Wallerawang Quarry Project

State Significant
Development
Modification Assessment
(DA 344-11-2001 MOD 3)

January 2020

Figure 4 Proposed disturbance stages

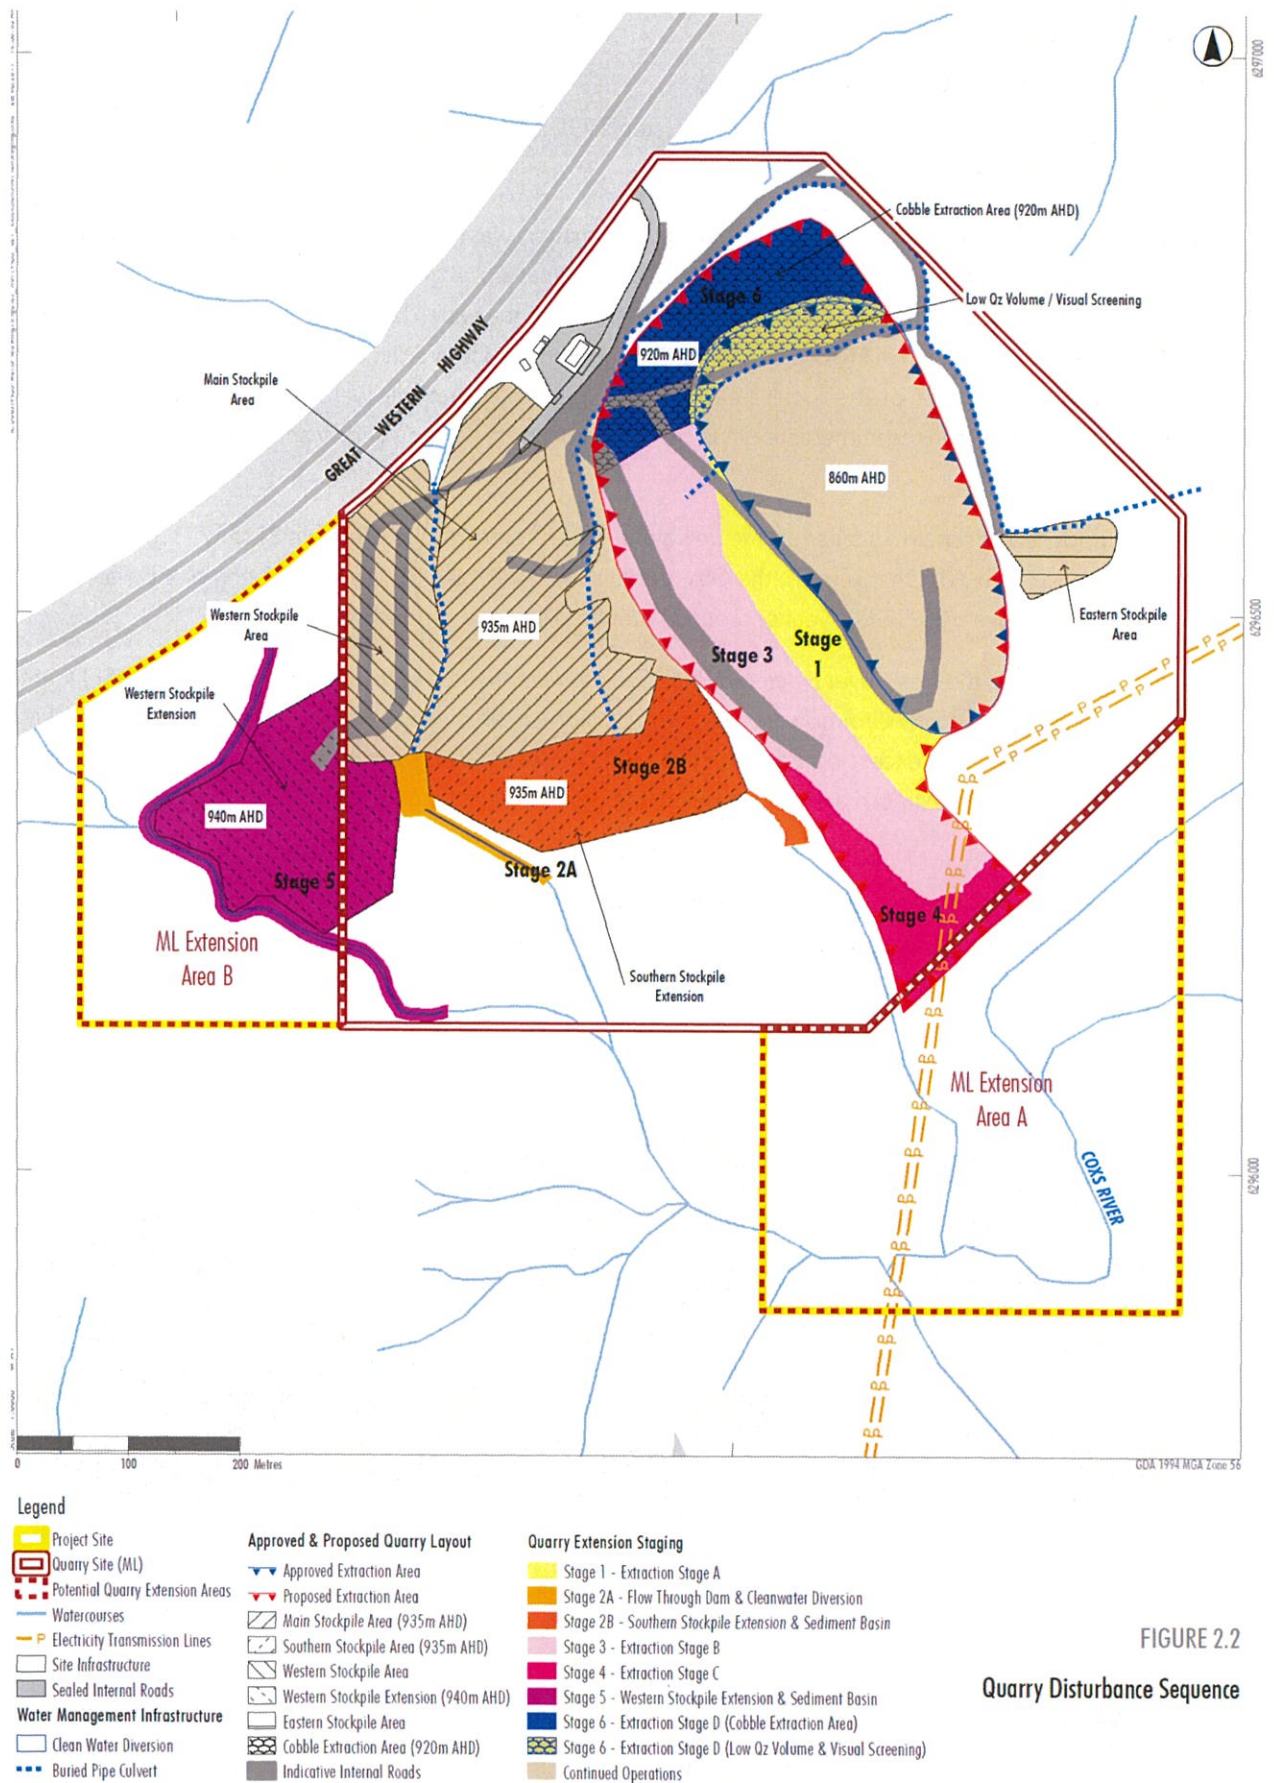
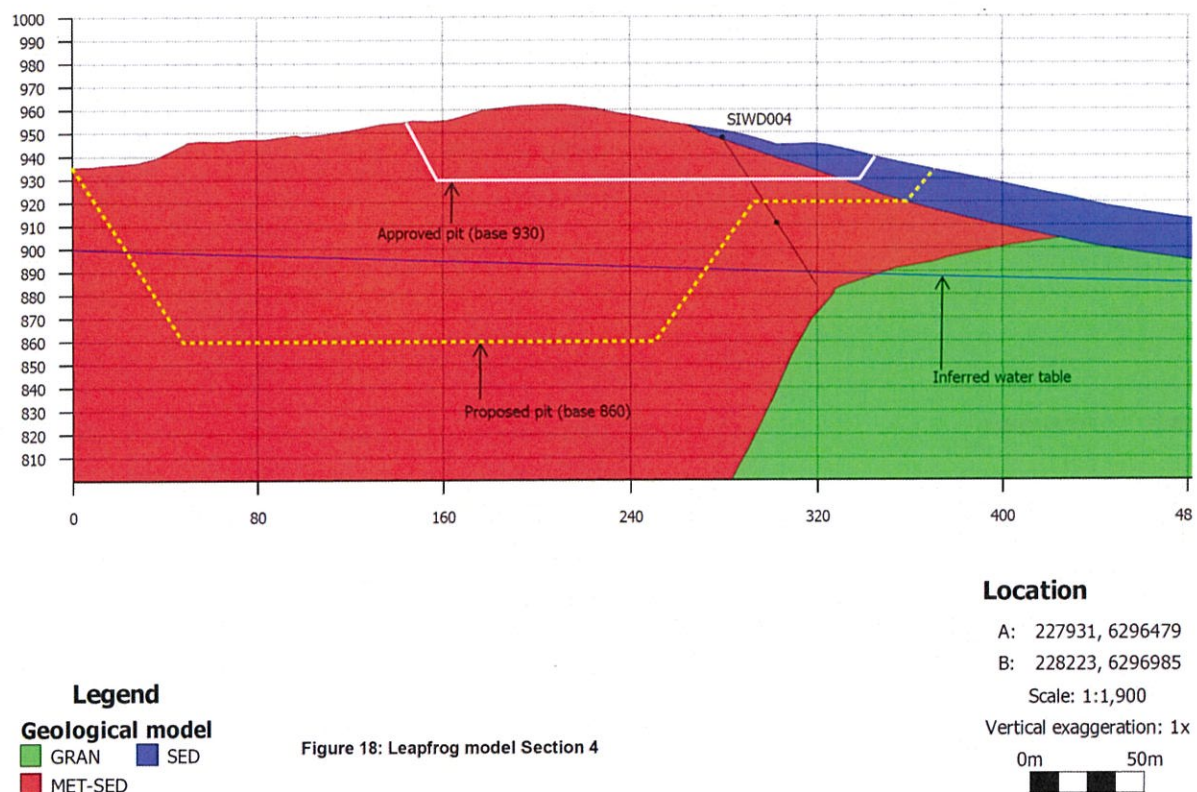
Walker requested, and the Department supports, a staged approach to the retirement of biodiversity credits. It is proposed that the required 487 credits be split into four tranches reflecting the proposed six quarry stages (see **Figure 4**) in the following manner:

As shown in **Figure 4**, Walker proposes that the modification would extend the Project in six distinct stages. The SEE's biodiversity assessment of vegetation proposed to be cleared has identified, by the use of the BAM, that 487 ecosystems credits would need to be retired to offset this proposed clearing. No species credits would need to be retired.

Figure 6 Groundwater bores and model drawdown contours – SEE proposal

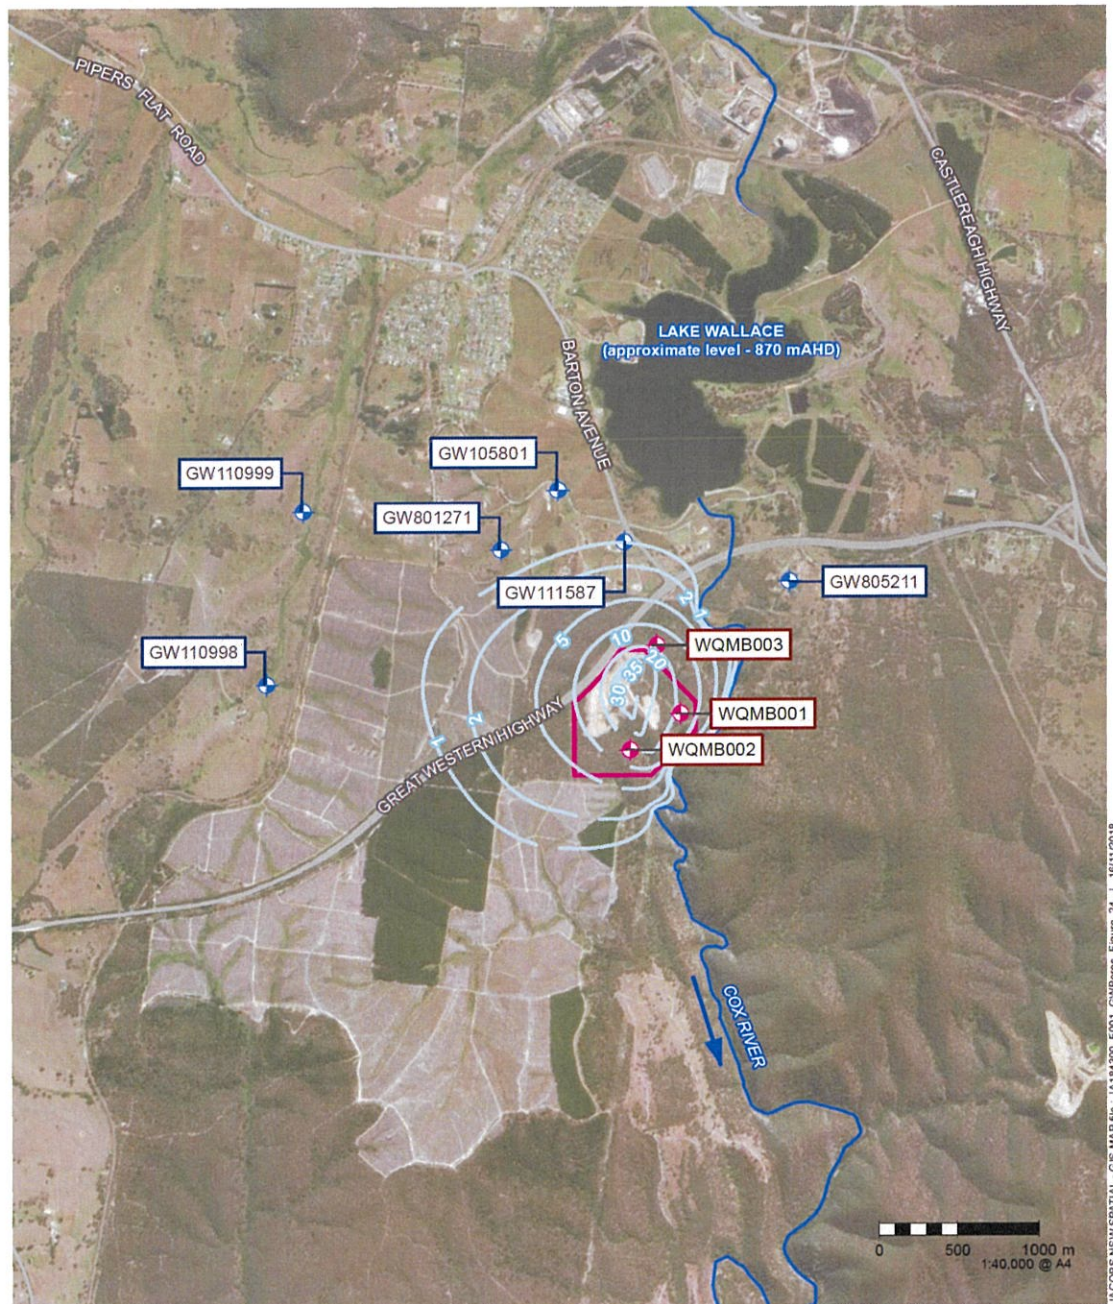
The proposal is subject to the requirements of the *NSW Aquifer Interference Policy* (AIP). The minimal impact thresholds of the AIP include that the drawdown at any bore should be less than two metres. The base case produced by the application of the groundwater model is shown in **Figure 6**. This figure indicates that the GW111587 bore to the north of the site is predicted to experience a drawdown of one metre under the original proposal. Other scenarios were modelled to account for some of the uncertainty that is inherent in groundwater modelling. The maximum predicted drawdown of any of these scenarios is four metres at the same bore, which would exceed the AIP's minimal impact threshold.

Walker maintained that the Project would not cause a change in the beneficial use of groundwater resources by other water users. The Department is not fully confident that this AIP criterion would be achieved under the original proposal. The Department considers that these matters should be considered as part of a revised GIA, prior to any approval to extract resources from below the water table.

- no longer seek to discharge water from the final void to Cocks River;
- not extract below 900 m AHD, unless approved by the Secretary;
- establish and map the wet-weather level of the water table on the site; and
- update and submit a revised GIA, based upon an improved data set for inputs to the groundwater model.

The Department considers that this is a reasonable approach to the uncertainties that exist with the current GIA and the concerns expressed by WaterNSW and the EPA. However, the Department agrees with the EPA that “a *contemporaneous environmental assessment and approval process at a later stage*” should be undertaken following the collection of a robust data set to support a revised GIA. This would be best achieved in the context of a subsequent development application or modification application, which would allow for the relevant agencies to conduct a thorough review of a revised GIA.

Figure 7 Location of Site #45-1-2802 (previously WQ1)

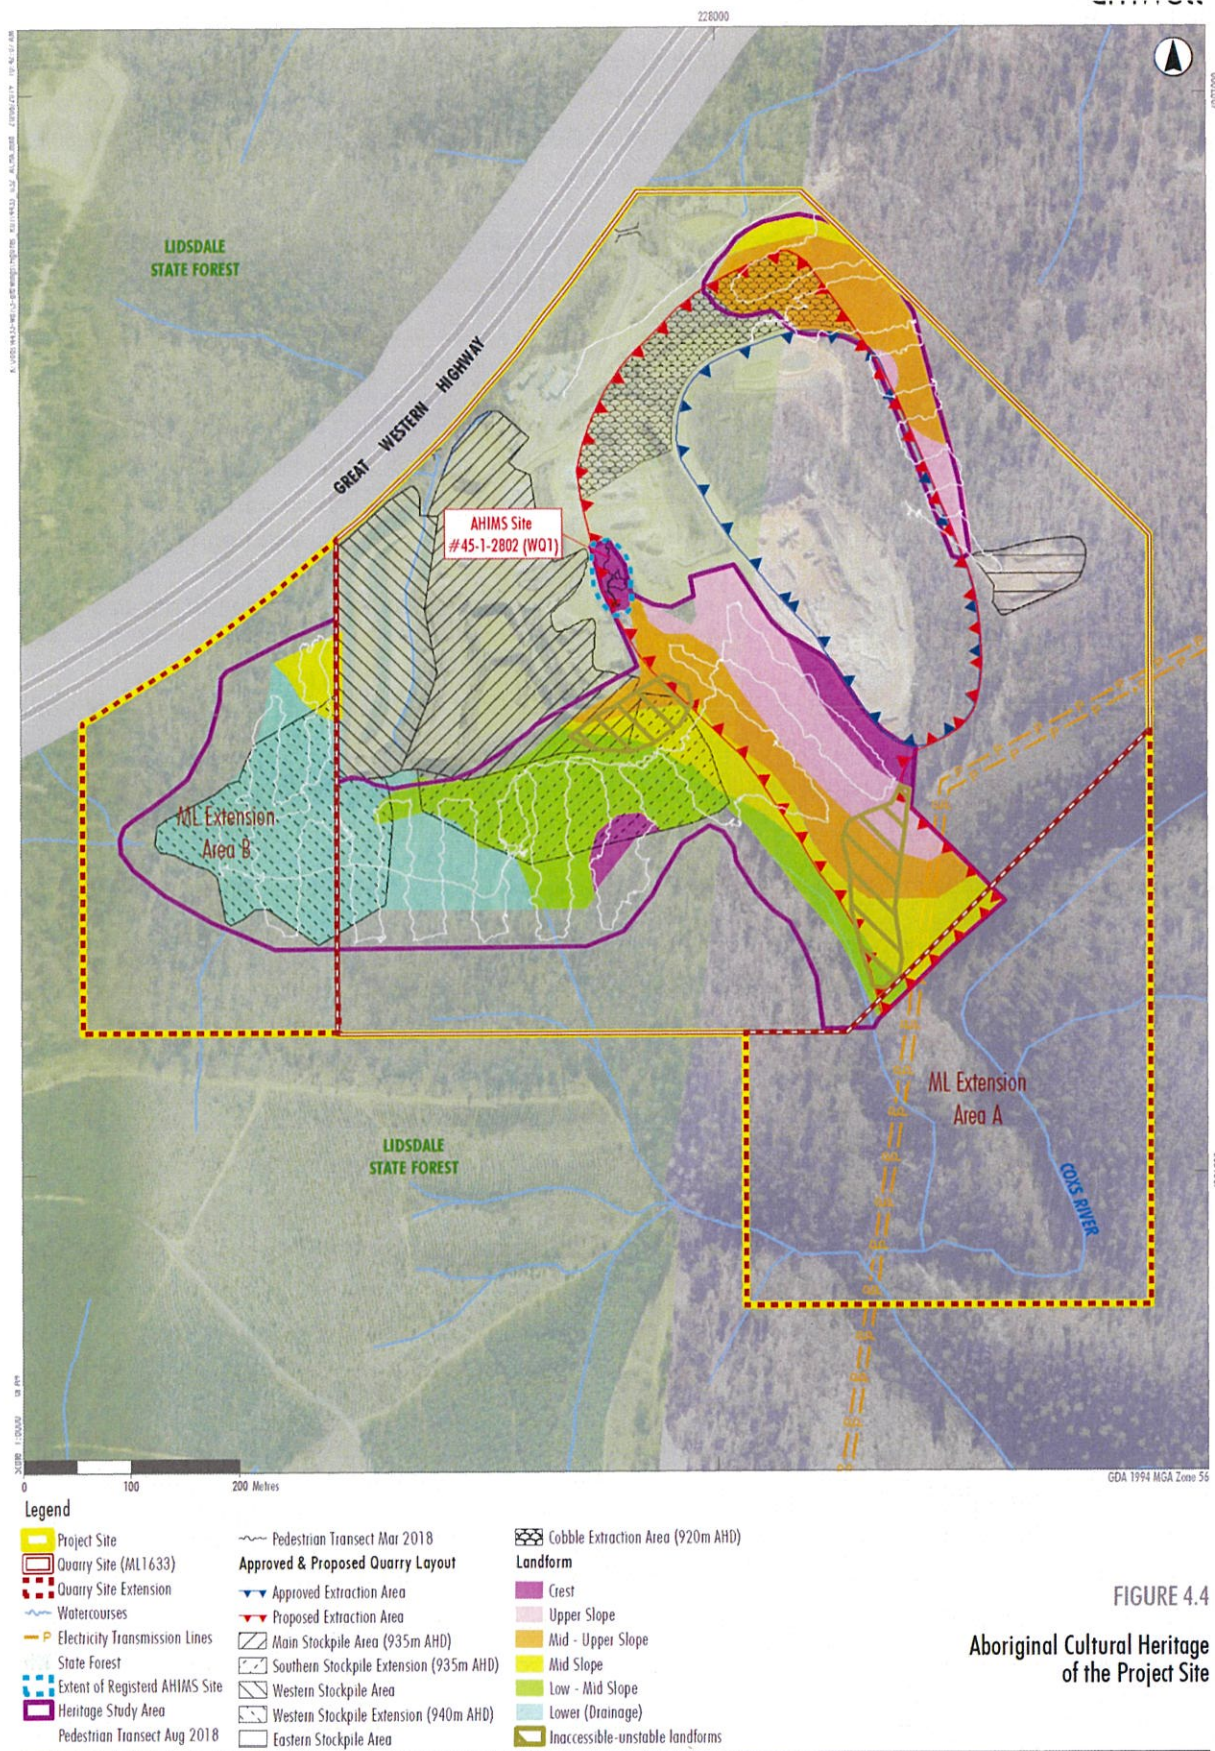
However, the proposed extension would destroy a site, previously known as WQ1, identified during studies conducted for the original Project in 2000. WQ1 was described in 2000 as being an artefact scatter, containing 22 artefacts, but when re-inspected in 2018, only 16 remained due to erosion and surface water flows. It was also identified in 2018 that the site had not been registered in the Aboriginal Heritage Information Management System (AHIMS) in 2000. The site was registered in AHIMS in 2018 and is now known as Site #45-1-2802 (see **Figure 7**).

The ACHA recommended that, subject to the agreement of the RAPs, salvage of the artefacts at Site #45-1-2802 be undertaken by a qualified archaeologist together with the RAPs. Limited salvage excavation is proposed, with all recovered artefacts to be reburied at a location agreed by the RAPs where no future developments are planned or likely.

- artefacts at Site #45-1-2802 to be salvaged and relocated to a safe location (agreed to by the RAPs) away from impacts arising from the project or other planned or future developments;

BCD considered that consultation with RAPs was conducted in accordance with the relevant guidelines and that the two RAPs had accepted the recommendations. The Department is satisfied that appropriate consultation with RAPs has been undertaken and that the planned treatment of Aboriginal cultural heritage on the site is appropriate. The Department has recommended conditions of consent that require Walker to produce an ACHMP for the site, in consultation with the RAPs and BCD, that incorporates the ACHA's recommendations. Site #45-1-2802 would be destroyed, with the artefacts salvaged and reburied at a location agreed by the RAPs.
